# A d d e n d u m

Iowa Department of Transportation  
Office of Contracts

<b>B.O.</b>	<b>Proposal ID</b>	<b>Proposal Work Type</b>	<b>County</b>	<b>Project Number</b>	<b>Addendum</b>
009	49-0521-097	BRIDGE REPLACEMENT - PPCB	JACKSON	BRFN-052-1(97)--39-49	18JUL009A02

### 376'-0 x 40' PRETENSIONED PRESTRESSED CONCRETE BEAM BRIDGE

DESIGN SHEET NO. 1 OF 61 FILE NO. 31055 DESIGN NO. 117

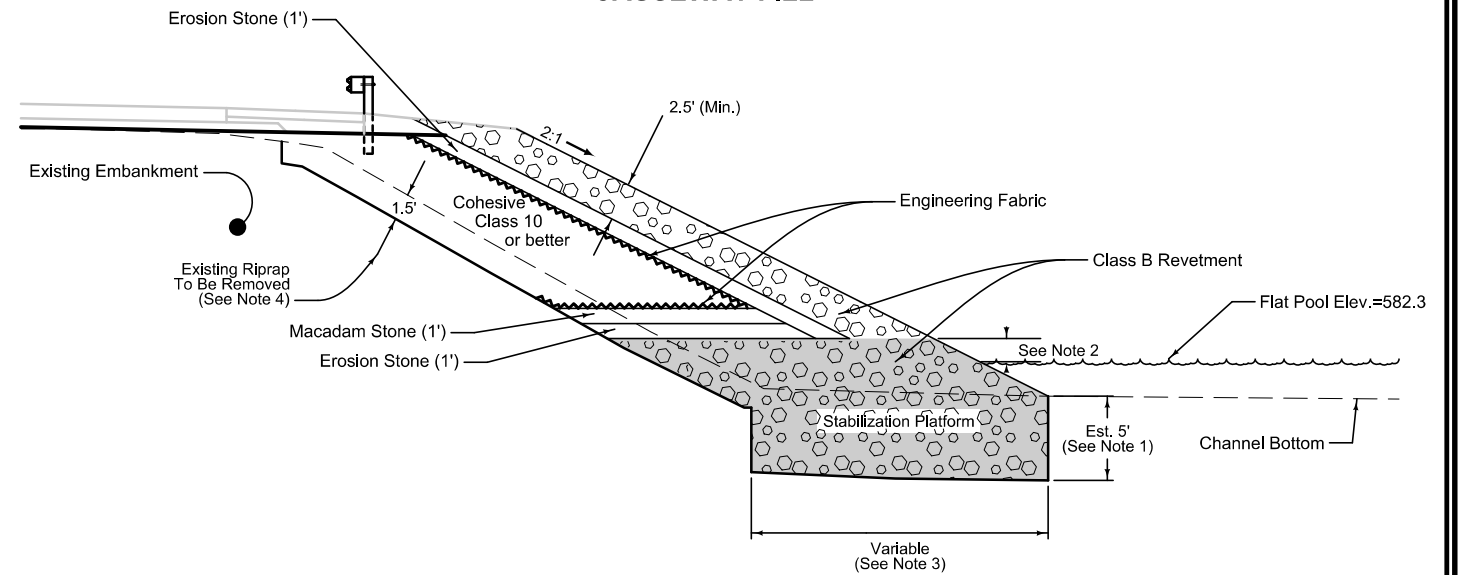
Add Proposal Line No. 0211 2402-2722000 EXCAVATION CLASS 22; 60.000 CY

Sheet 2 - Added Class 22 excavation quantity & reference information.  
Sheet J.1 - Site 3 notes.  
Sheet Q.1- Revised note No.11

30	FOR REMOVING REVETMENT THAT MAY BE OVER DRILLED SHAFT AREAS.
